SWIM PROJECT PROFILE

SWIM PROJECT PROFILE		File No. : 1
Regist. No. : Agency No. : DPWH-1	Name: SAYTAN DAM & RESERVOIR SWIP	
Region: 1	Province: LA UNION	Municipality: SAYTAN, PUGO
Present Status: 1. Pre-F/S() ② F/S(1983) ③ D/D(-)		
Purpose: Major : Irrigation Incidental : IF, FG, MH		
Project Feature:

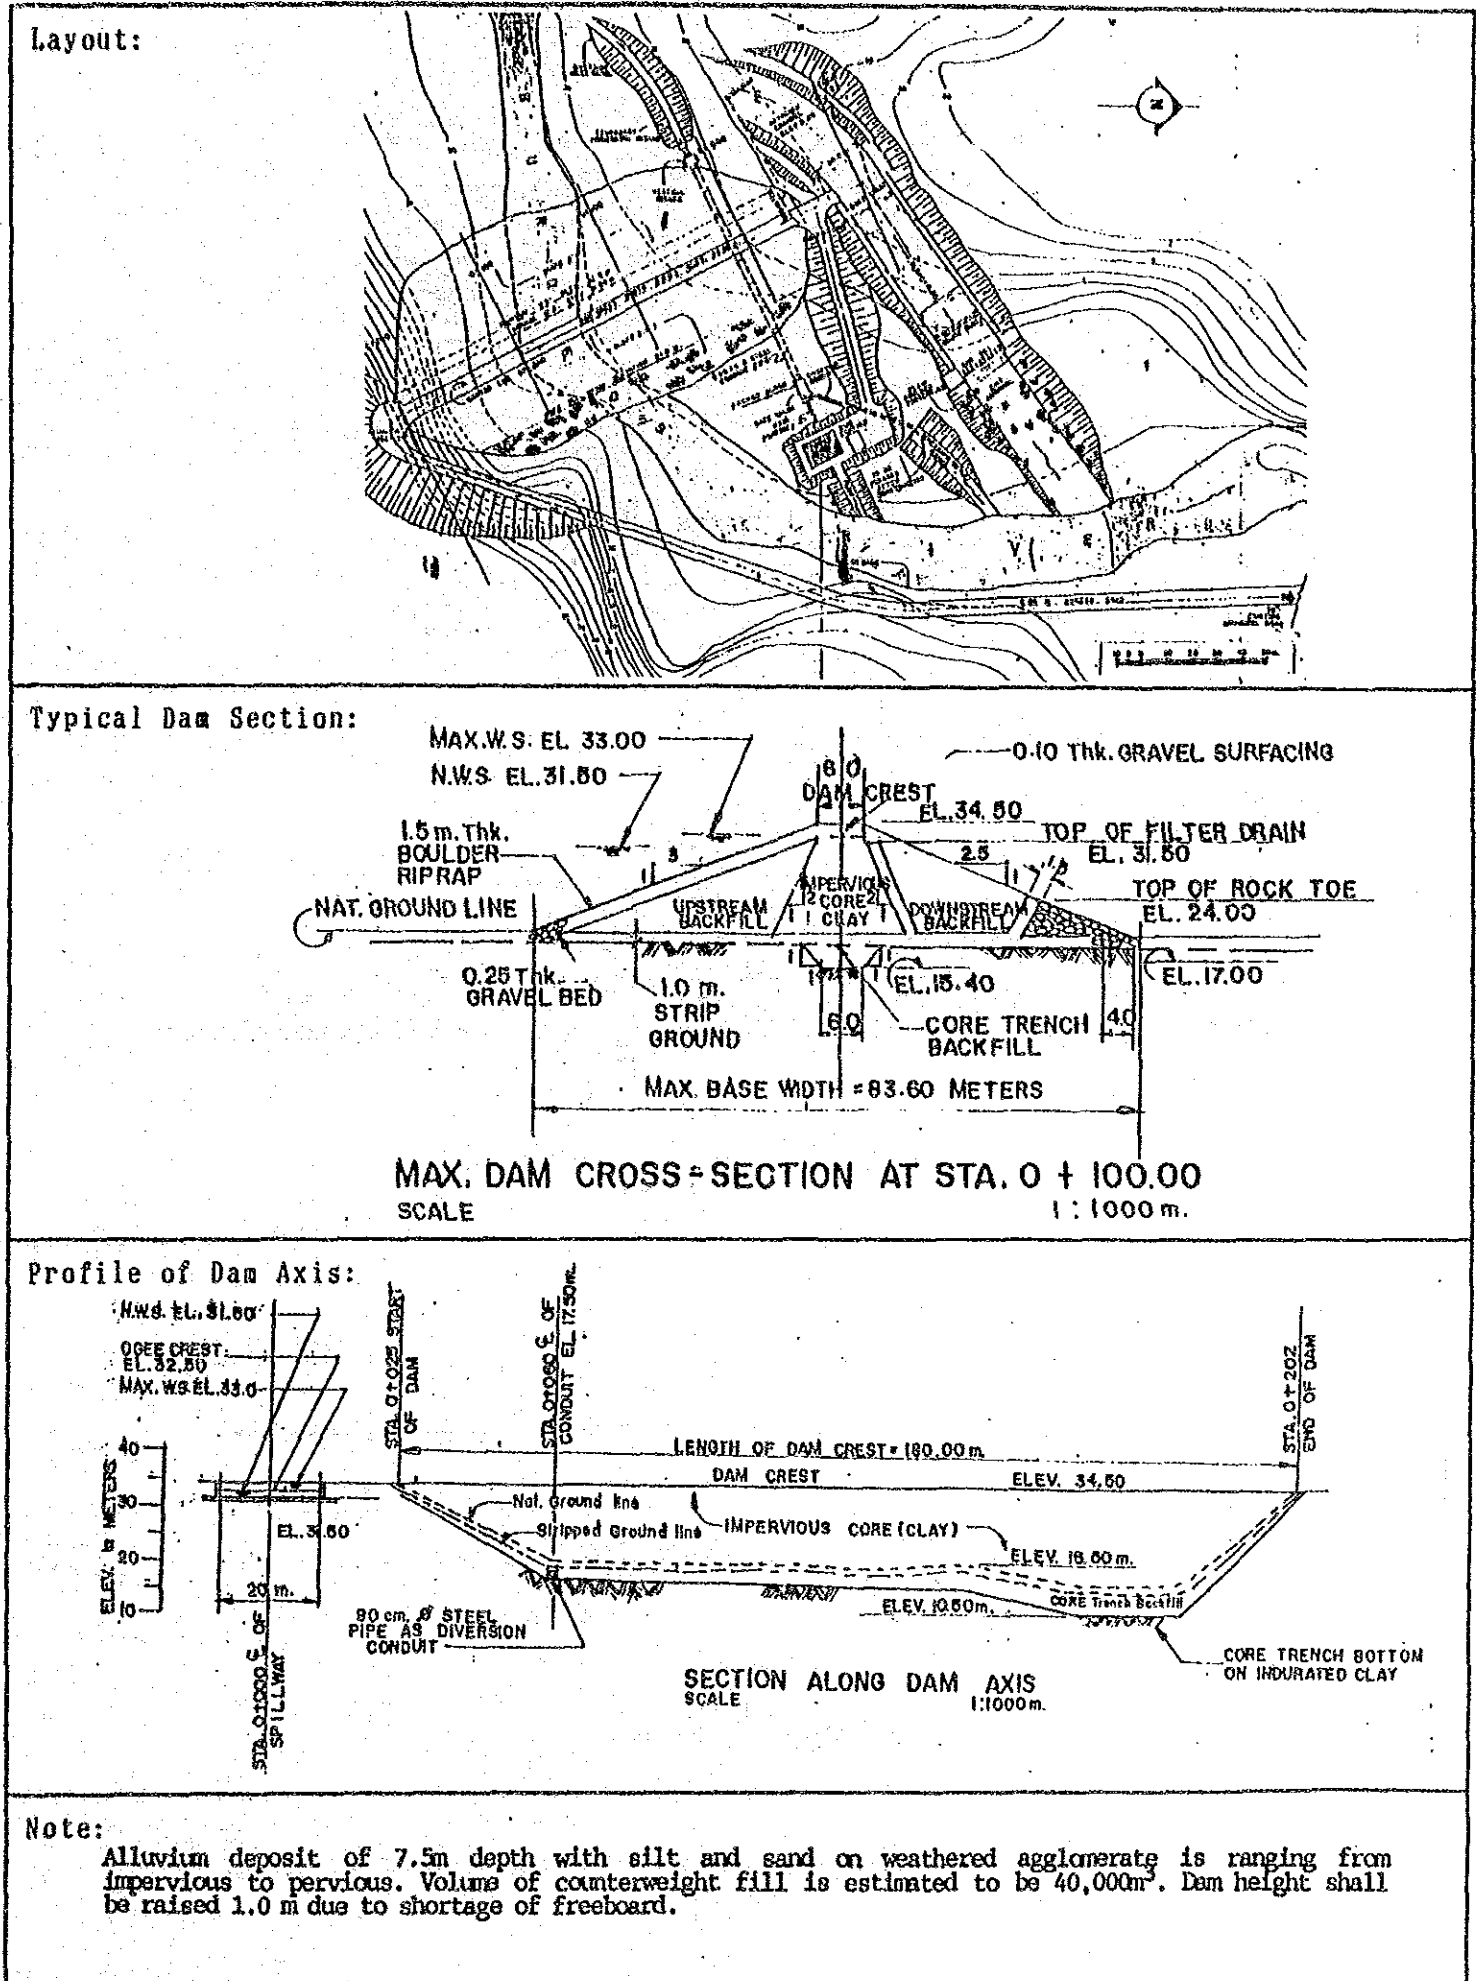
6. Inland Fishery	: Annual Production	: 21 ton/year
Technical Assessment:		
1. Survey and Investigation: Bearing capacity and permeability in alluvium river bed shall be measured. Soil mechanical test for the dam embankment materials shall be conducted.

2. Planning Agricultural benefit, mini-hydro. benefit and annual production of inland fishery are over-estimated. Watershed management plan is not formulated. Construction cost is not properly estimated. Project planning shall be re-formulated.

3. Design Impermeable blanket cut-off in upstream are recommendable and counterweight is necessary to prevent sliding on soft foundation. Freeboard is not enough for 200 years' flood. Transition of energy dissipator in downstream is not smooth. Inlet of outlet works is recommended to be located in outside of the dam embankment.

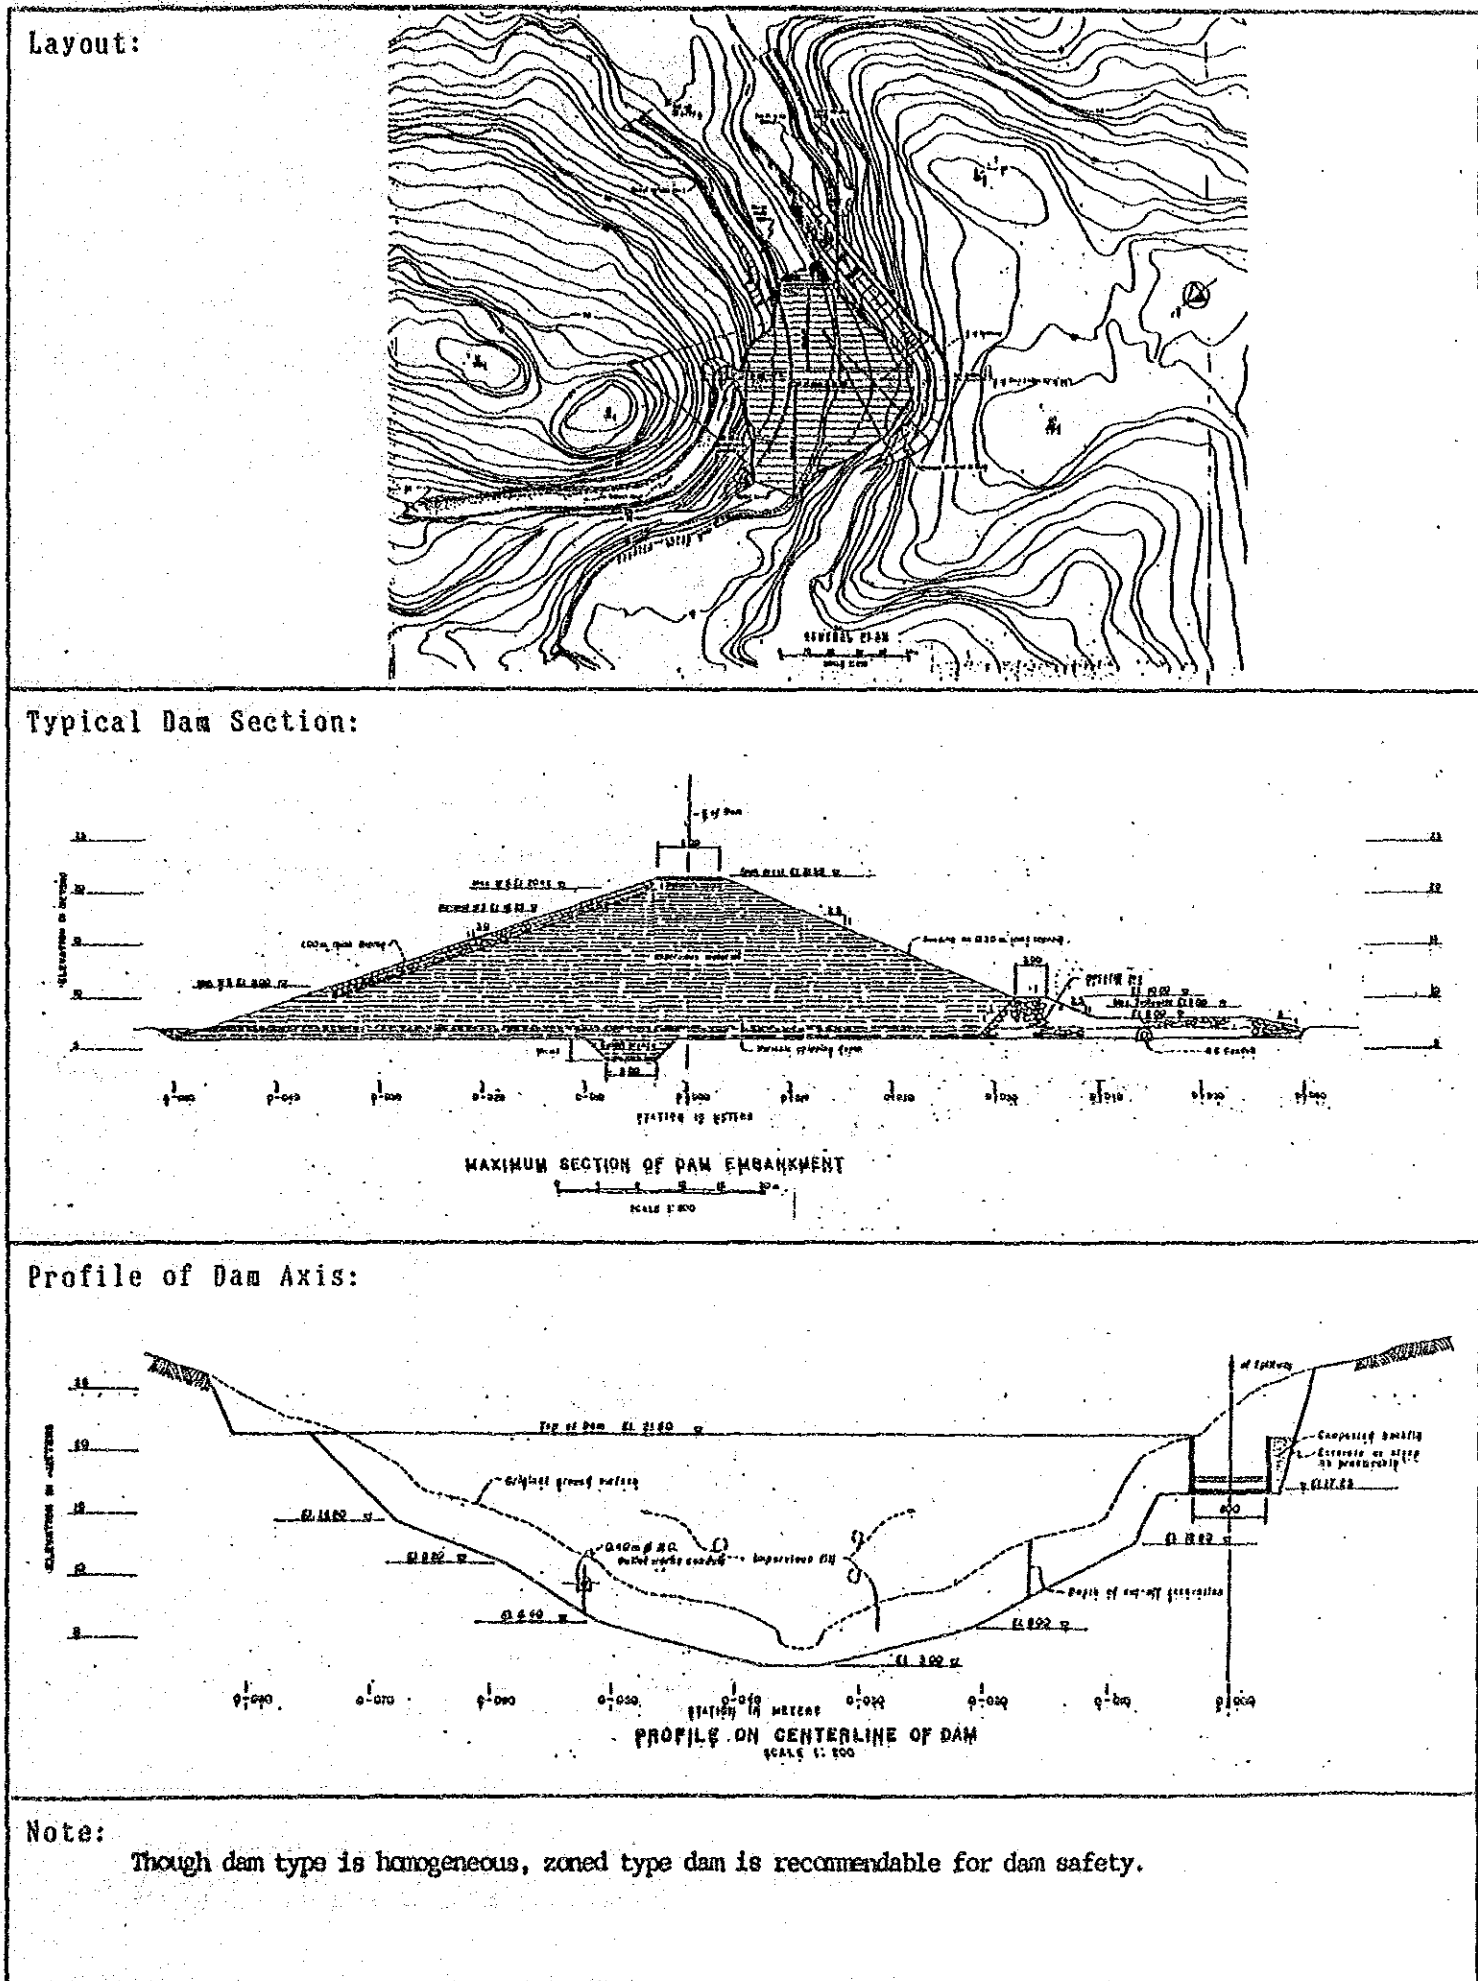
6. Inland Fishery	: Annual Production	: 8 ton/year
Technical Assessment:		
1. Survey and Investigation: Additinal investigation for Metro-Hydro shall be conducted. Permeability test in the dam foundation shall be conducted. Soil mechanical test for the dam embankment materials shall be conducted.

2. Planning Agricultural production of inland fishery is over-estimated. Project planning shall be re-formulated.		
3. Design Zoned type with impervious blanket is recommended instead of proposed homogenous type. Some measures against percolatdion failure on the contact face between embankment and spillway shall be considered. Centerline of the conduit of outlet works is recommended to be straight.

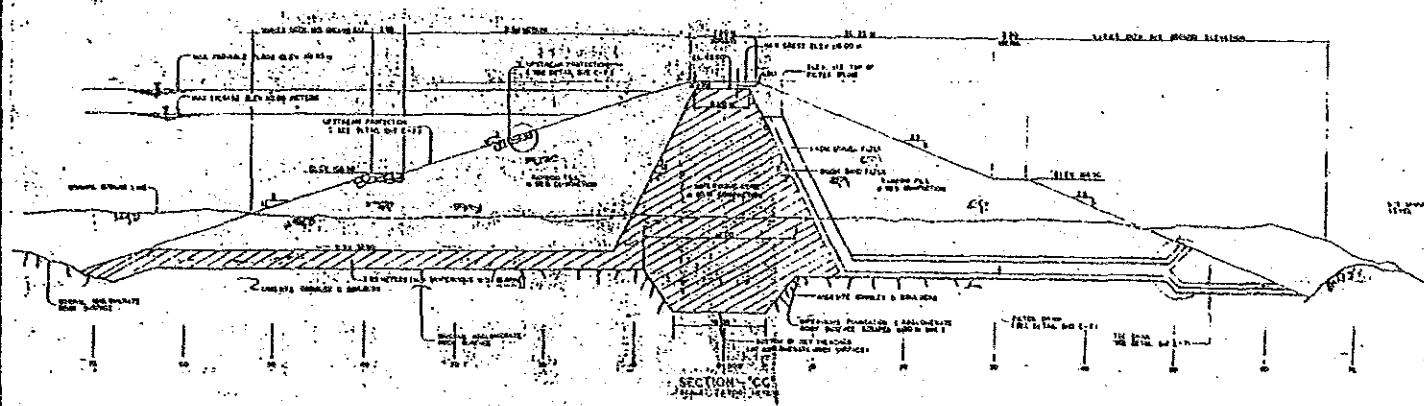
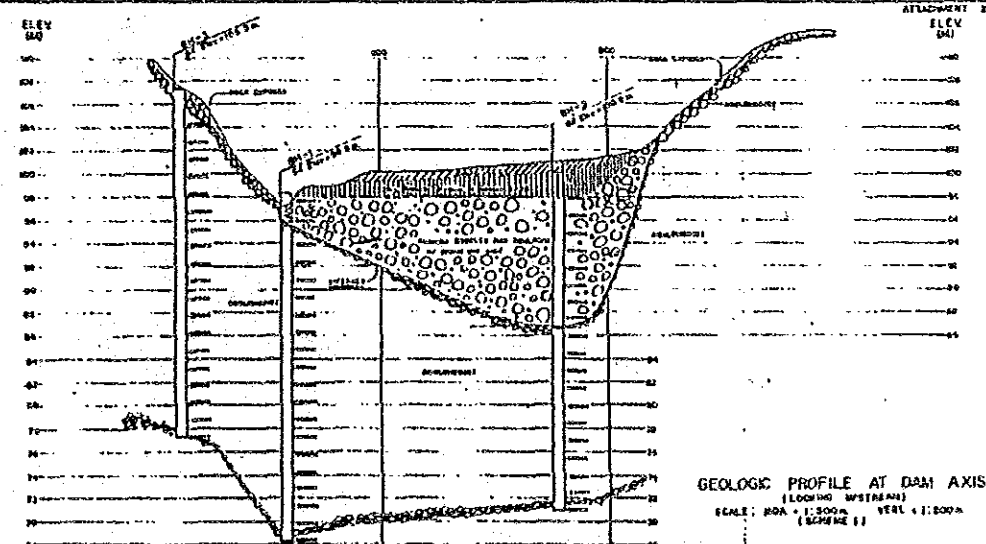
6. Inland Fishery	Annual Production : 10 ton/year	
Technical Assessment:		
1. Survey and Investigation:		
Investigation for Meteo-hydro shall be conducted.		
Scale of topographic map for reservoir site shall be more than 1/2,000.		
Depth of cobbles and boulders shall be clarified.		
Soil mechanical test for the dam embankment materials shall be conducted.

2. Planning		
Run-off analysis and determination of reservoir capacity are not properly studied.		
Environmental conservation plan is not formulated.		
Construction cost and economic evaluation are not properly estimated.

3. Design		
Continuous underground wall joining with the blanket is recommended instead of the core trench.		
Spillway is recommended to be changed from drop inlet type to chute type one.		
Freeboard in the spillway is slightly small comparing with its water depth.		
Design of appurtenant structures is not conducted.

Eleven meter's deep layer of sand and gravel with permeability ($k=3 \times 10^{-2}$ cm/sec) covers river bed. Continuous underground wall, of which area is roughly 620 m² is estimated. Dam height shall be raised 0.5 m because of freeboard shortage.

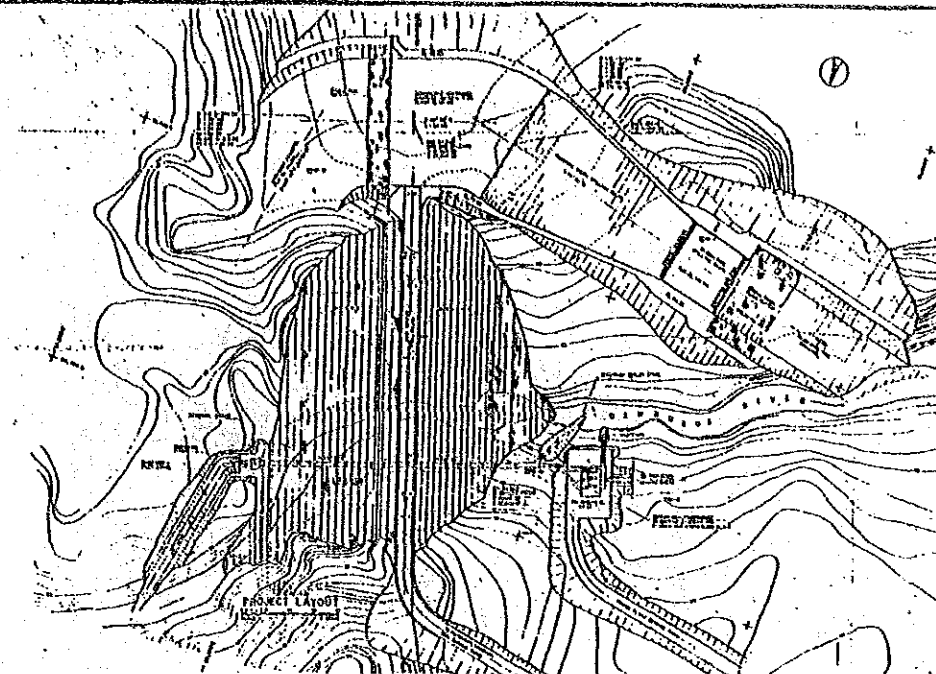
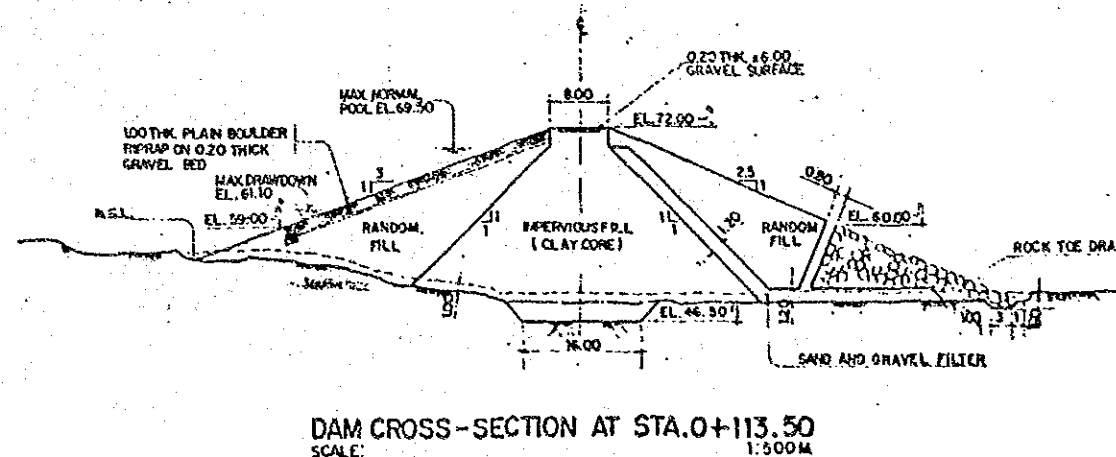
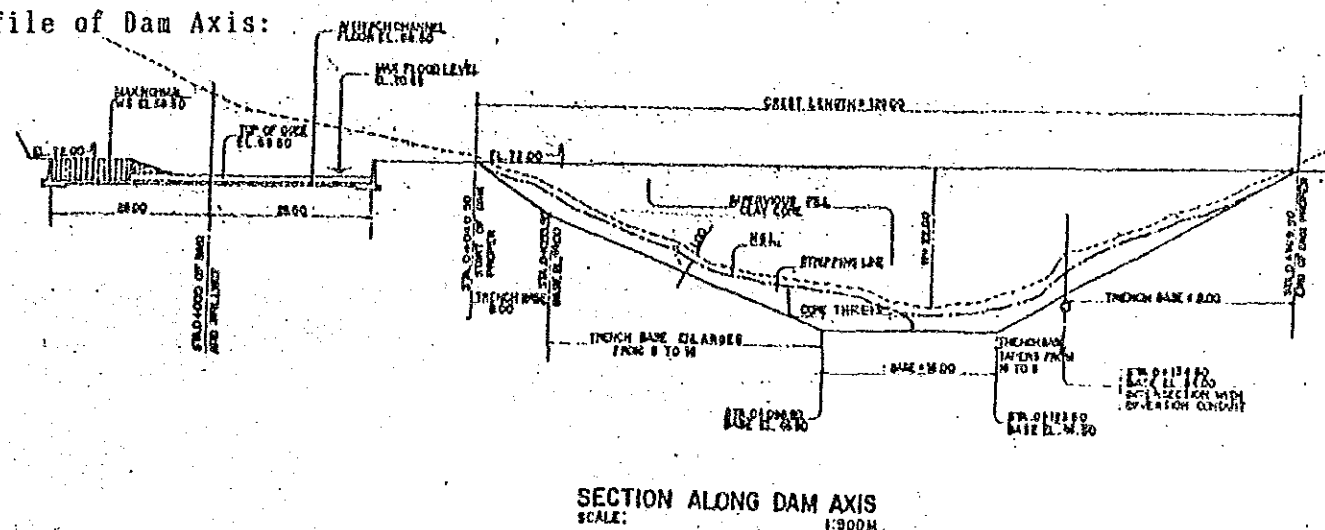
6. Inland Fishery	Annual Production : 78 ton/year	
Technical Assessment:		
1. Survey and Investigation: Topographic maps shall be coverd the whole project area in a scale of 1/500. Scale of the topographic map for reservoir site is not mentioned. Soil mechanical test for the dam embankment materials shall be conducted.

2. Planning Scale of mini-hydropower is not suitable. Mini-hydro. beniefit is over-esitimated. Water supply plan and watershed management plan are not formulated.

3. Design Contact clay shall be laid on the base of core trench to prevent the percoliation failure through the contact face. Width of supercritical flow section in the spillway should be uniform.

High weathered clay covering in reservoir area could function effectively as natural blanket.
